COMPTROLLER GENERAL OF THE UNITED STATES
WASHINGTON, D.C. 20548

B-177148

COMMENTS ON QUESTIONS RAISED BY MAIWALD-BENSON
AND ASSOCIATES AND DISCUSSION OF HUD'S
REASONS FOR NOT SELECTING THE WATERS CONSTRUCTION
COMPANY AS THE PROJECT DEVELOPER

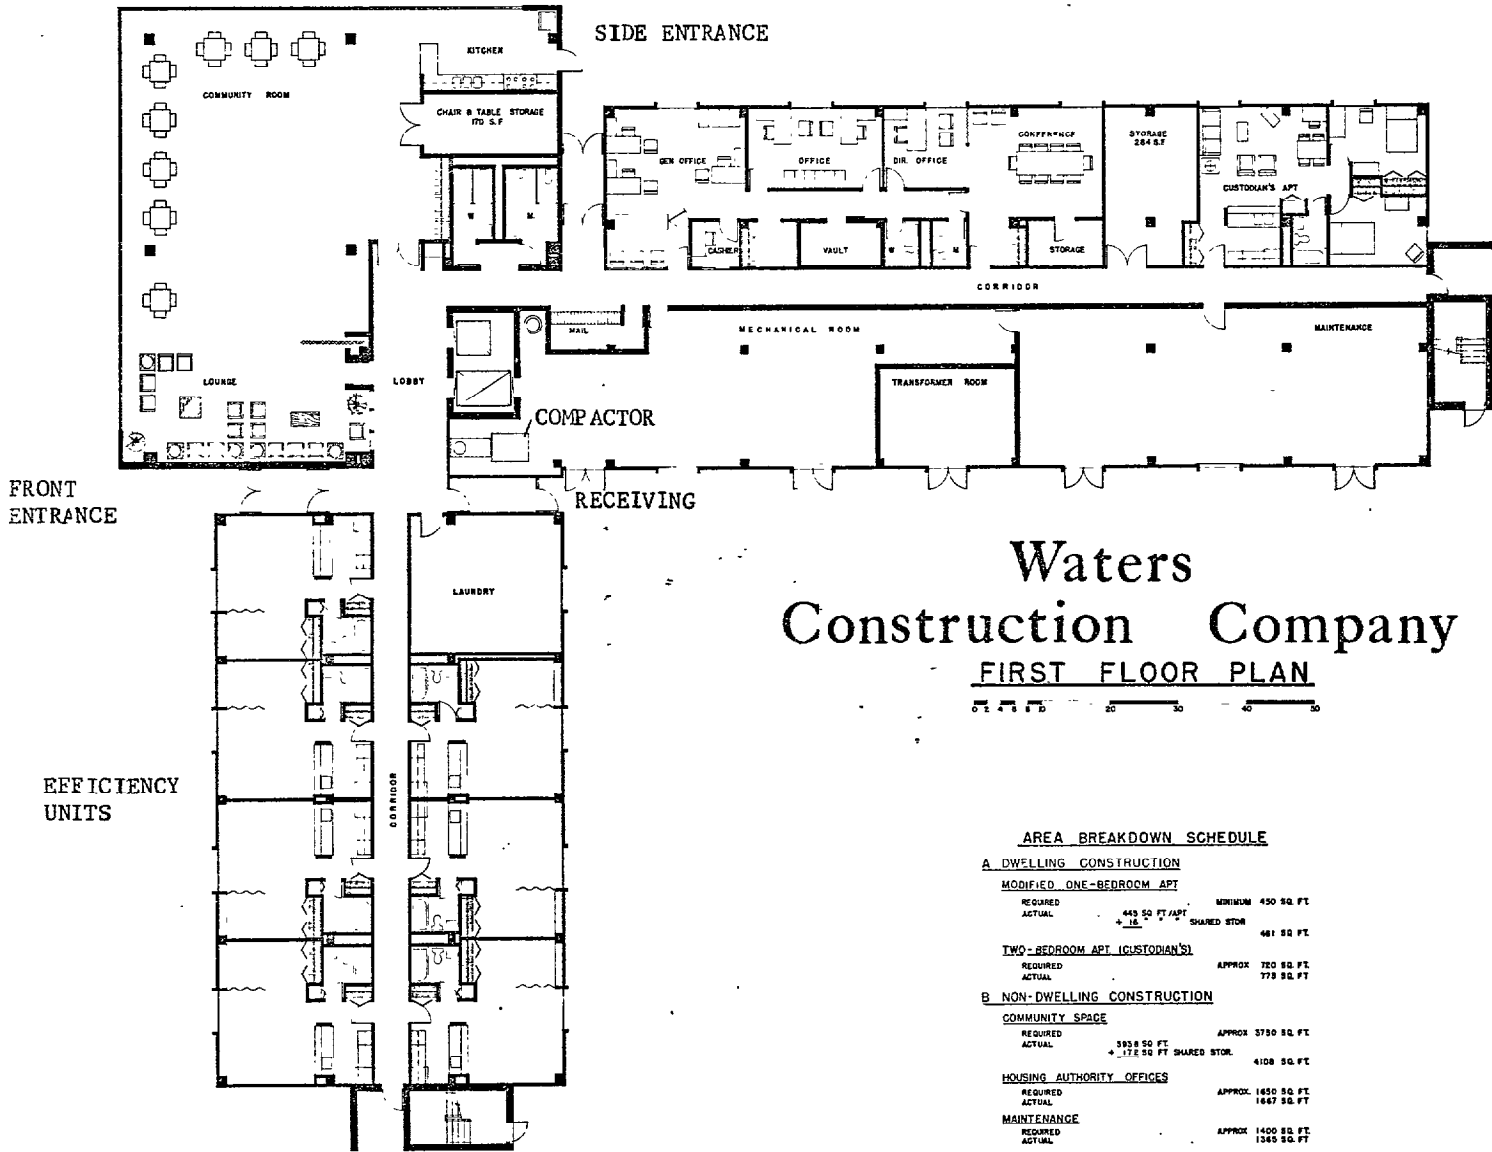
"Building has too many entrances for efficient traffic control and building function."

Mr. Sich said the Waters proposal provided for two main entrances--a vehicular traffic entrance and a side entrance adjacent to the general offices. According to Mr. Sich, the traffic entrance could not be observed from the general offices and traffic control would be poor. (See exhibit A.)

"Receiving, trash and Mechanical Rooms are combined. This is not acceptable."

HUD Minimum Property Standards provide that trash rooms be enclosed and separated from the rest of the building. The Waters proposal provided for a trash compactor in an unenclosed room which was not separated from the rest of the building. (See exhibit A.)

**COM-FAM CORPORATION
FIRST FLOOR PLAN**

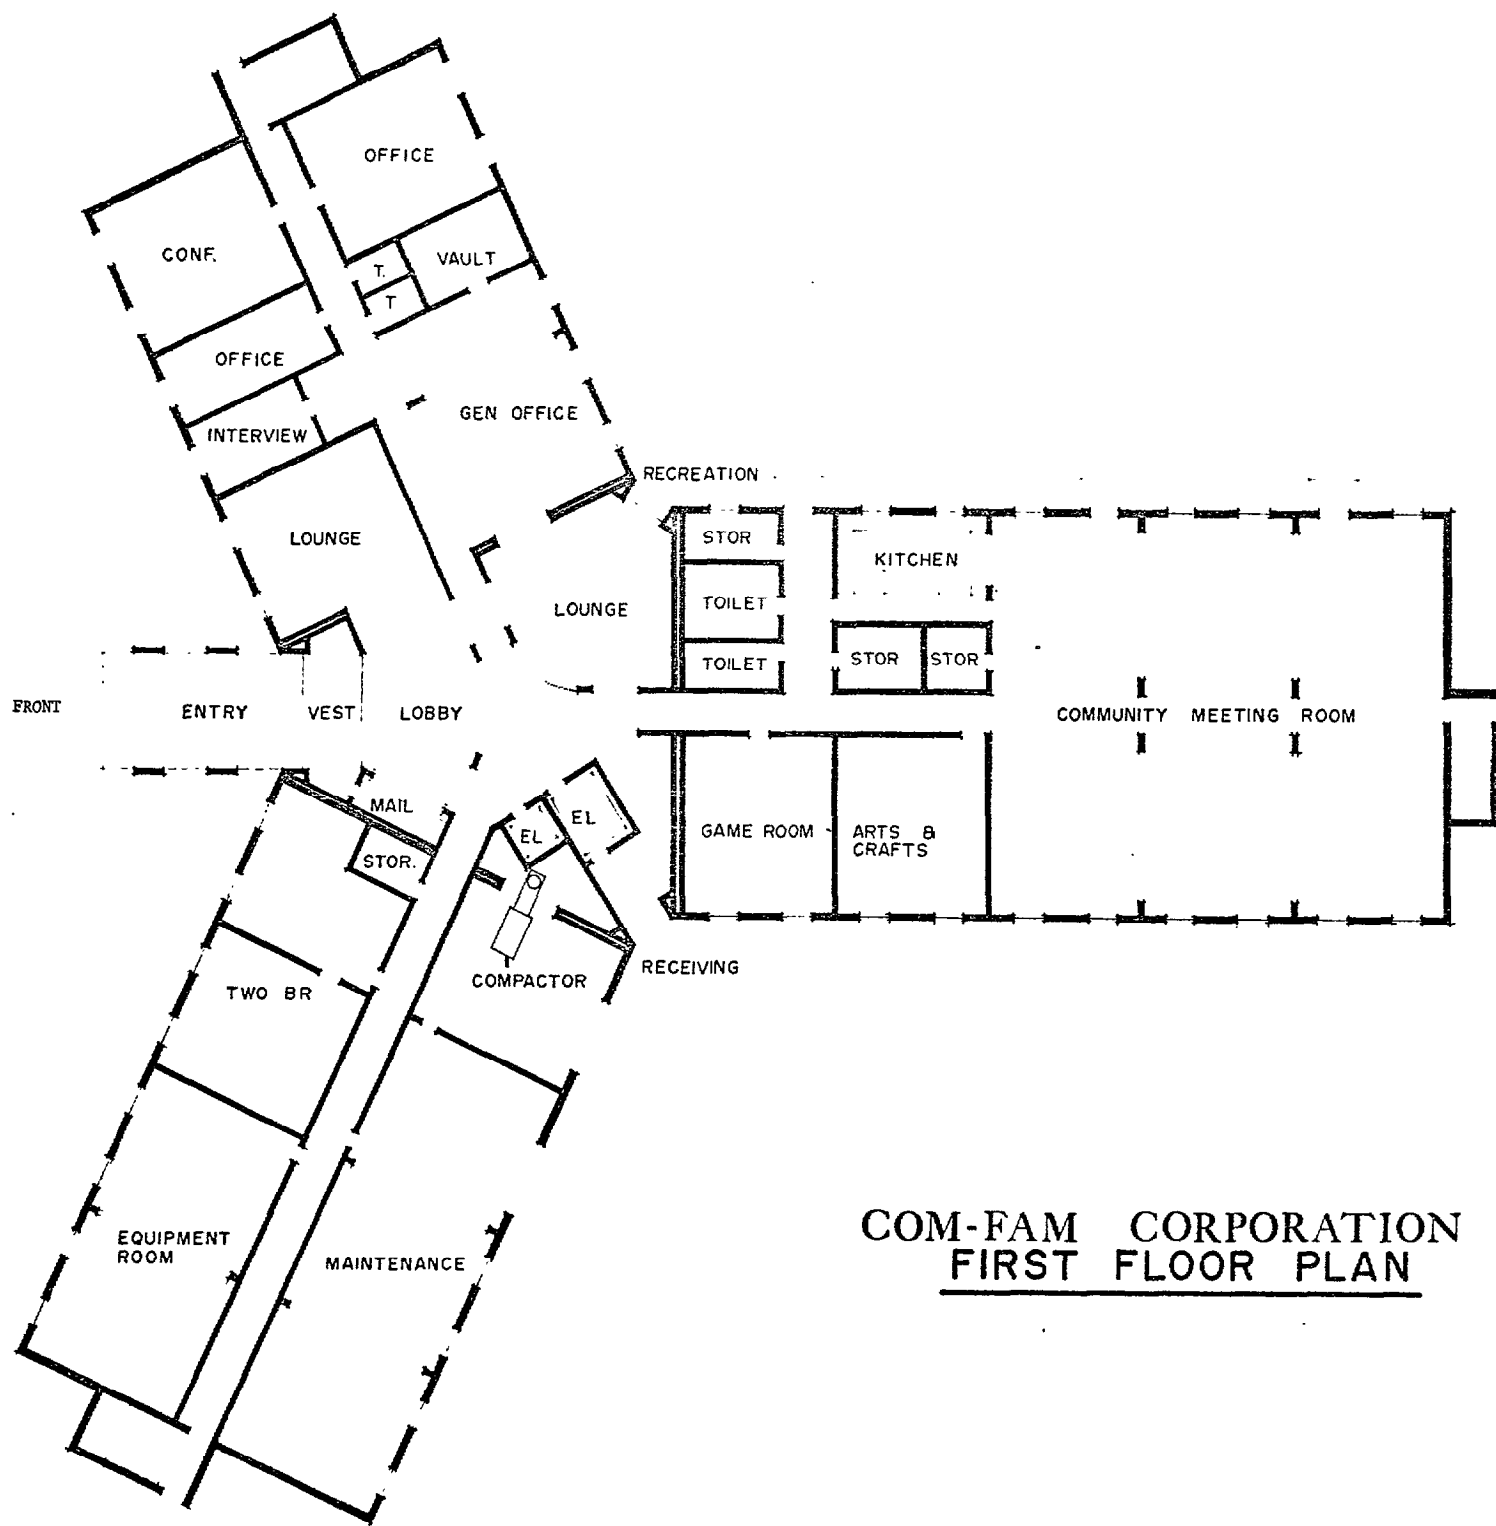
Mr. Sich told us that rough sketches of the building and unit plans, as provided by Com-Fam, were adequate during the proposal stage.
